ECE/TRANS/WP.29/2008/112
24 July 2008

Proposal for Supplement 8 to the 05 series of amendments to Regulation No. 83
(Emissions of M₁ and N₁ vehicles)

Submitted by the Working Party on Pollution and Energy (GRPE) */

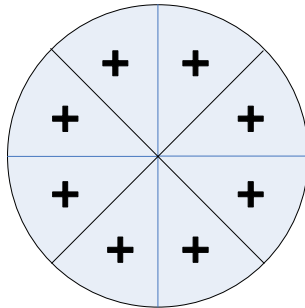
Paragraph 6.1.3., amend to read:

"6.1.3. A current of air of variable speed shall be blown over the vehicle. The blower speed shall be within the operating range of 10 km/h to at least 50 km/h, or as an alternative, at the request of the manufacturer, within the operating range of 10 km/h to at least the maximum speed of the test cycle being used. The linear velocity of the air at the blower outlet shall be within ± 5 km/h of the corresponding roller speed within the range of 10 km/h to 50 km/h. At the range over 50 km/h, the linear velocity of the air shall be within ± 10 km/h of the corresponding roller speed. At roller speeds of less than 10 km/h, air velocity may be zero.

The above mentioned air velocity shall be determined as an averaged value of a number of measuring points which:

- (a) For blowers with rectangular outlets are located at the centre of each rectangle dividing the whole of the blower outlet into 9 areas (dividing both horizontal and vertical sides of the blower outlet into 3 equal parts).
- (b) For circular blower outlets, the outlet shall be divided into 8 equal arcs by vertical, horizontal and 45° lines. The measurement points lie on the radial centre line of each arc (22.5°) at a radius of two thirds of the total (as shown in the diagram below).

Each value at those points shall be within 10 per cent of the averaged value of themselves.

The device used to measure the linear velocity of the air shall be located at between 0 and 20 cm from the air outlet.

The final selection of the blower shall have the following characteristics:

- (i) Area: at least 0.2 m²;
- (ii) Height of the lower edge above ground: approximately 20 cm;
- (iii) Distance from the front of the vehicle: approximately 30 cm.

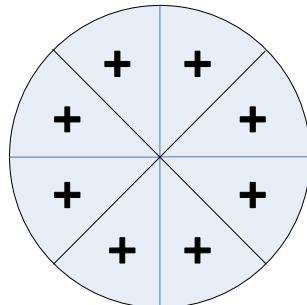
Paragraph 3.4.2., amend to read:

"3.4.2. A current of air of variable speed shall be blown over the vehicle. The blower speed shall be, within the operating range of 10 km/h to at least 50 km/h, or as an alternative, at the request of the manufacturer within the operating range of 10 km/h to at least the maximum speed of the test cycle being used. The linear velocity of the air at the blower outlet shall be within ± 5 km/h of the corresponding roller speed within the range of 10 km/h to 50 km/h. At the range over 50 km/h, the linear velocity of the air shall be within ± 10 km/h of the corresponding roller speed. At roller speeds of less than 10 km/h, air velocity may be zero.

The above mentioned air velocity shall be determined as an averaged value of a number of measuring points which:

- (a) For blowers with rectangular outlets are located at the centre of each rectangle dividing the whole of the blower outlet into 9 areas (dividing both horizontal and vertical sides of the blower outlet into 3 equal parts).
- (b) For circular blower outlets, the outlet shall be divided into 8 equal arcs by vertical, horizontal and 45° lines. The measurement points lie on the radial centre line of each arc (22.5°) at a radius of two thirds of the total (as shown in the diagram below).

Each value at those points shall be within 10 per cent of the averaged value of themselves.

The device used to measure the linear velocity of the air shall be located at between 0 and 20 cm from the air outlet.

The final selection of the blower shall have the following characteristics:

- (i) Area: at least 0.2 m^2 ;
- (ii) Height of the lower edge above ground: approximately 0.2 m;
- (iii) Distance from the front of the vehicle: approximately 0.3 m.
